Submissions Report

SSD-10383 – Modification 1

2 Darcy Road, Westmead

Catholic Schools Parramatta Diocese

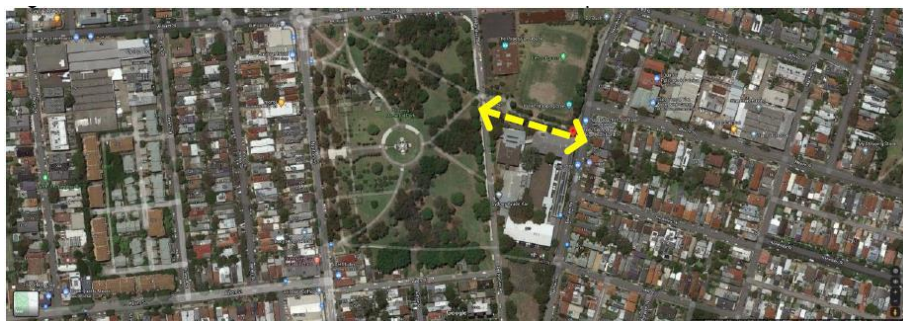
Condition B1(b) is therefore fair and ensures that the connection to the east relates directly to the orderly development of the entire block to ensure the site has adequate pedestrian access which is consistent with the Draft Westmead Place Strategy 2036 for their own students and staff. Its removal is not supported.

subject site is not a public place, it is private land, therefore there is no reason why the site needs to provide public pedestrian connectivity in order to respond to this Strategy. In any event, the applicant agrees to indicating a future pedestrian connection to the western boundary of the site which would enable connectivity with the “potential new pedestrian creek crossing” west of the site as shown in the diagram below.

Therefore, the applicant's proposed wording of Condition B1(b) is now:

- (b) ensure the diagram prepared under (a) provides for a possible future pedestrian connection linking **the east-west pedestrian link to Bridge Road (to the west) including possible access through the adjoining properties to the west and the riparian zone, the primary school to the western boundary of the site.**

Moore Street Cycleway – public land physically separated from school campus

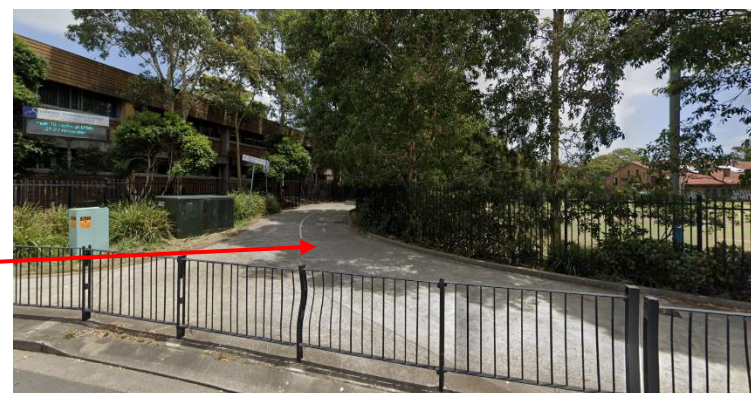
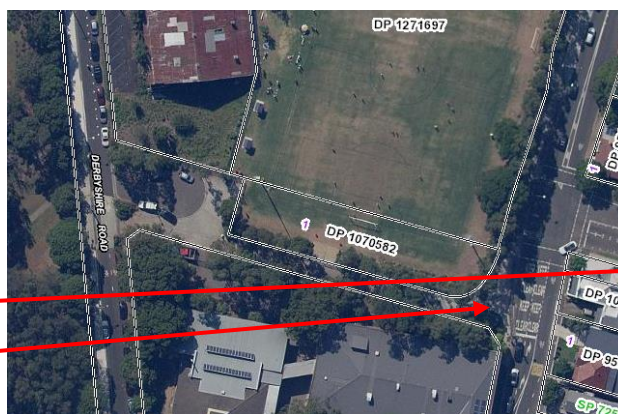
E4(d) – This condition is required as it allows for the orderly development of the site as detailed above in Council's objection to B1(b). Providing Public Access can be provided safely and has been demonstrated in similarly large campus schools such as Leichhardt Secondary School, see below aerial map, which like the Westmead Catholic Campus is a large property which separates two parts of the suburb.

The provision of public access through the Leichhardt campus of the Sydney Secondary College is not relevant to this Modification Application. The land ownership and planning history of that school site are not known and are likely to be completely different to the current circumstances.

The public access referred to in the aerial map is a cycleway that appears to be located on public land (with no lot and DP reference) and is therefore technically outside the boundaries of the school. This is very different to the circumstances of the subject site which is all privately owned land.

Furthermore, the cycleway is separated from the school grounds by secure fencing that would prevent access by the general public to school grounds. As stated in the Modification Application, security/fence lines within the subject site cannot occur until the high schools are redeveloped and consolidated into the centre of the campus. Indicatively, this would occur as part of future stages of the site's redevelopment. Therefore, the applicant is not in a position to provide any public access as part of the current application, and a comparison to the Sydney Secondary College in this regard is totally inappropriate.
